INSERVICE	INSPECTION	REV. 6
ISO. NO.: MCFI 1SV3		
DUKE PIPING CLASS: ASME SECT III CL. B		
SYSTEM SYMBOL: M, STEM VENT TO ATRP, ZN R8		
PIPING SPEC.: SVOI PS 900.2		
DRAWING NO.: MC-1419-13-20-00 (0402)		
PROJECT: MCGUIRE		
NUCLEAR SAFETY RELATED		
REVISION		
NO.	ORIG. CHGD. APPR.	DATE
1		
2		
3		
4

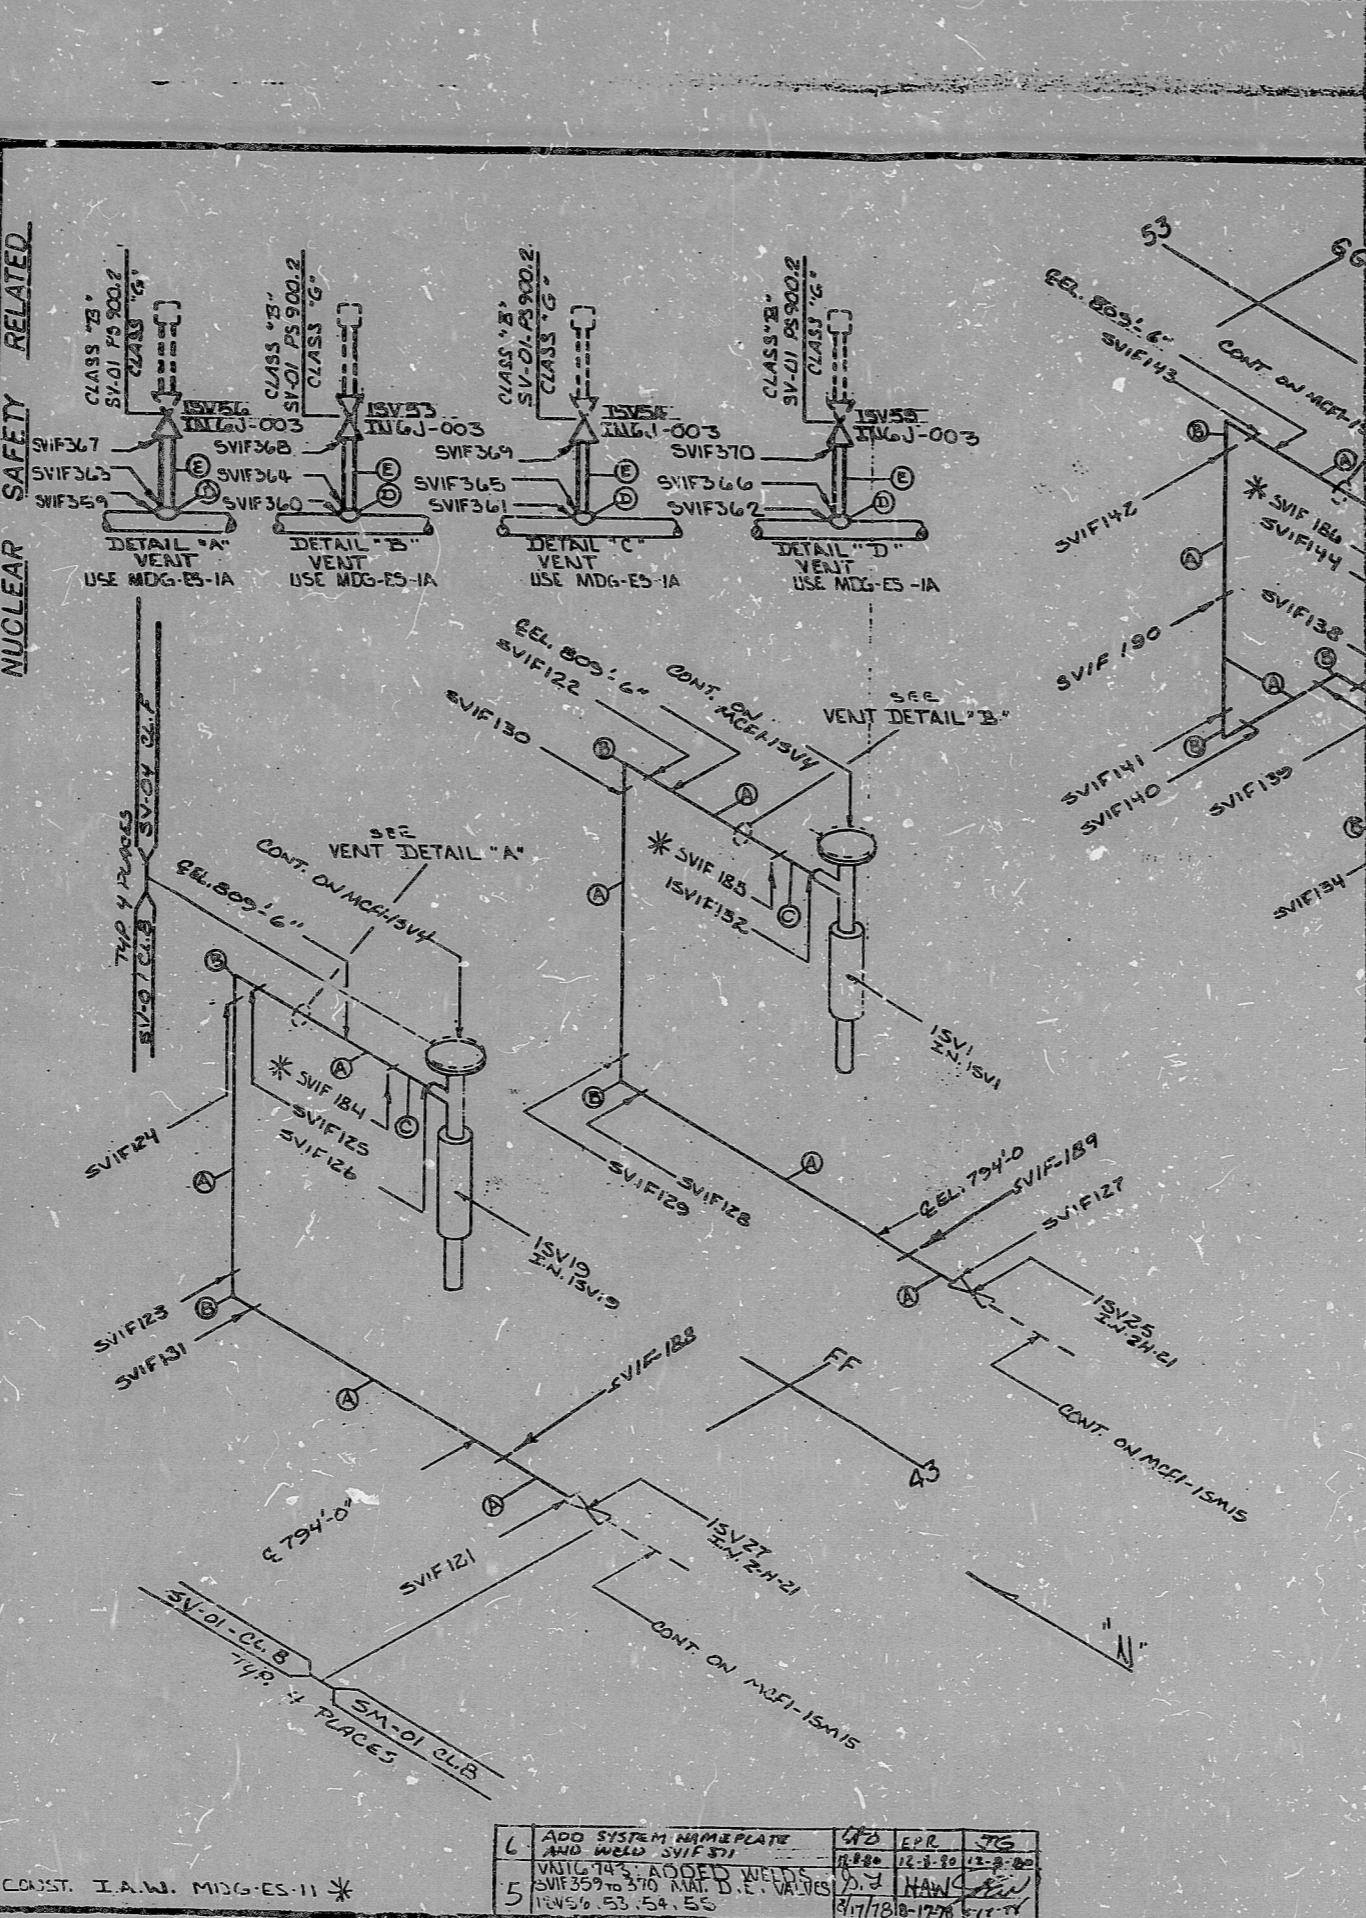
6	ADD SYSTEM NUMBER PLATE AND WELD SVIF 371	4/23	EPR	JTS
5	WELD 74'S, ADDED WELDS SVIF 359 TO 370, MAT. D. E. VALVES 12V5% 53, 54, 55	12-20	HAW	12-2-00
